Request	-	Special Use Permit of Major Public Utility - Water towers
Location	-	1910 Northover Road
Applicant	-	City of Toledo Dept. of Public Utilities 420 Madison Avenue, 4 th Floor Toledo, OH 43604
Owner	-	City of Toledo One Government Center Toledo, OH 43604

The staff recommends that the Toledo City Plan Commission recommend approval of SUP26-0002, a Special Use Permit for a major public utility – water towers at 1910 Northover Road, to Toledo City Council for the following **one (1)** reason:

SPECIAL USE PERMIT
TOLEDO CITY PLAN COMMISSION
REF: SUP26-0002
DATE: March 12, 2026
TIME: 2:00 P.M.

**DISTRIBUTION SYSTEM IMPROVEMENTS
ELEVATED STORAGE TANKS AND PUMP STATIONS - PHASE 1**

SITE PLAN

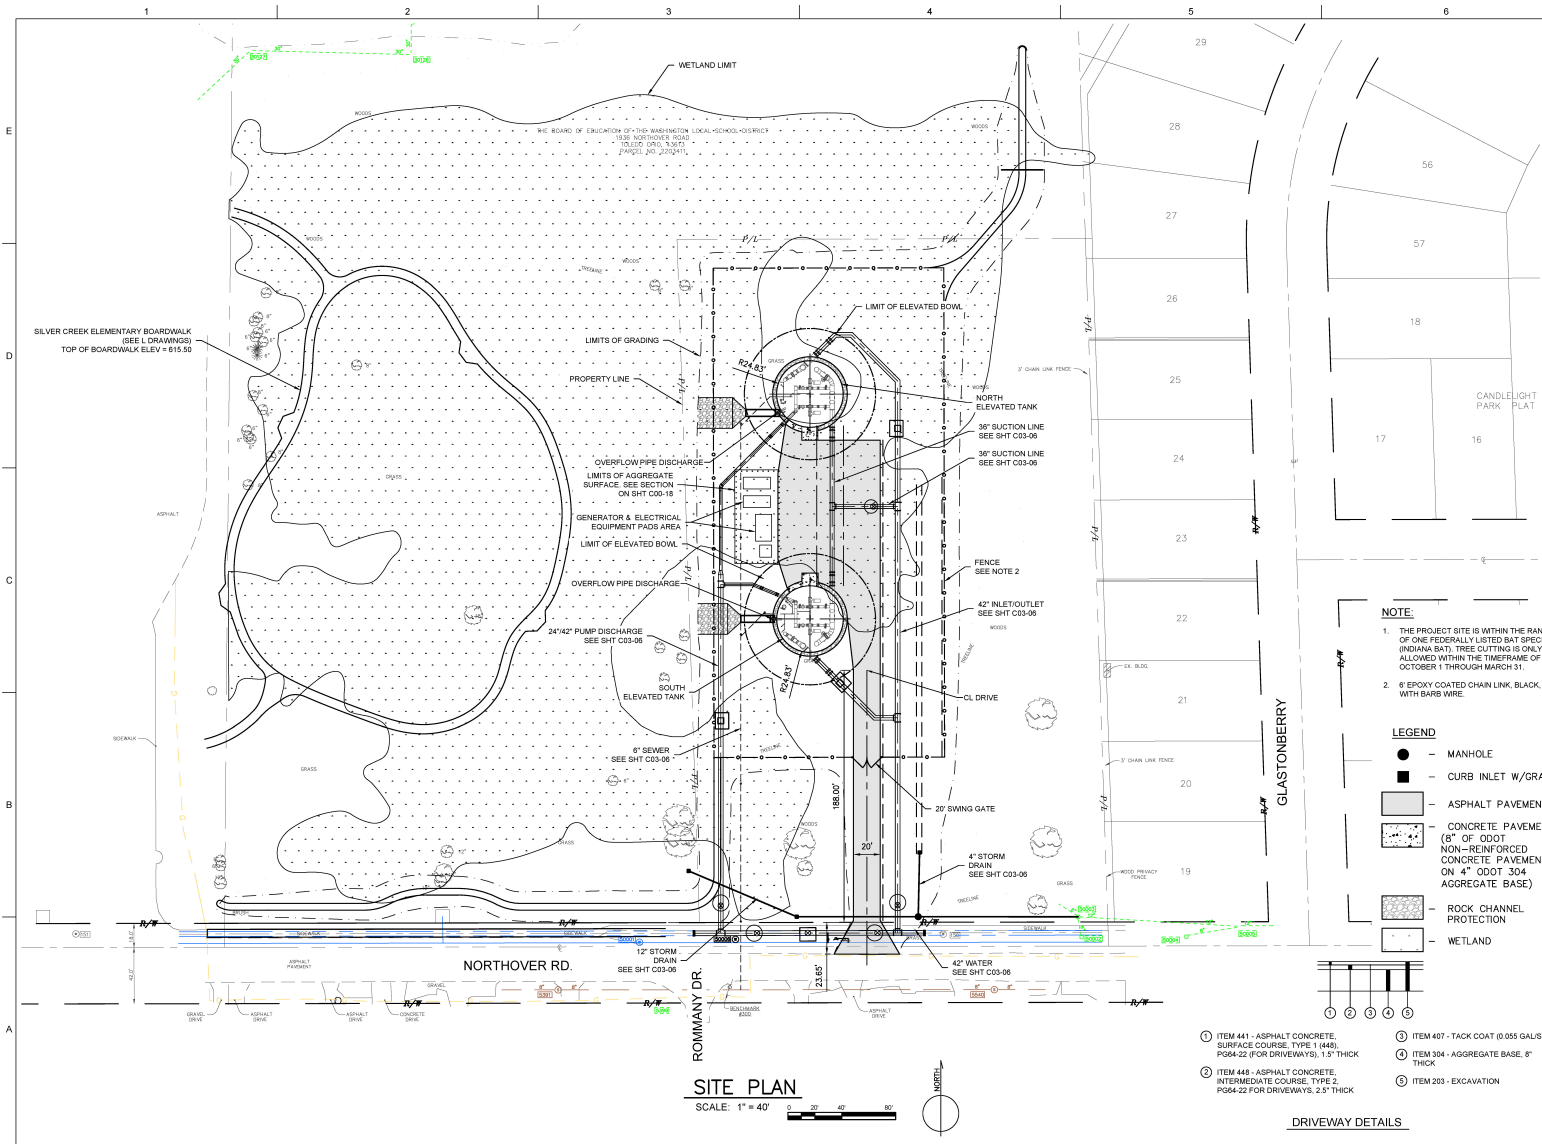
25. The use of barbed wire, razor wire, concertina wire or the like shall not be permitted in any zoning district except the Industrial districts and then only in the side and rear yards which not within 50 feet of a Residential district, not in the front yard setback and not anywhere along a street right-of-way. **Not acceptable as depicted. Six-foot (6’), epoxy coated chain link, black, with barb wire is not permitted within Residential Zoning Districts. Revised site plan showing fencing appropriate in Residential Zoning Districts is required.**

- a. A Type A Landscape buffer is required where Industrial Zoning Districts abut Residential Zoning Districts. A Type A Landscape buffer is required around the perimeter of the site to screen the base of the towers and equipment from abutting residential uses. **Not acceptable as depicted. A landscape plan depicting a Type A Landscape buffer where the proposed fence is shown is required.**

- e. The location, height and materials for any fencing to be installed and maintained. **Not acceptable as depicted. Fencing which is permitted in Residential Zoning is required.**

- f. The location and direction of any proposed lighting shall be identified (lights are to be directed away from adjacent residential properties). **Not acceptable as depicted. Lighting shall be clarified for approval.**
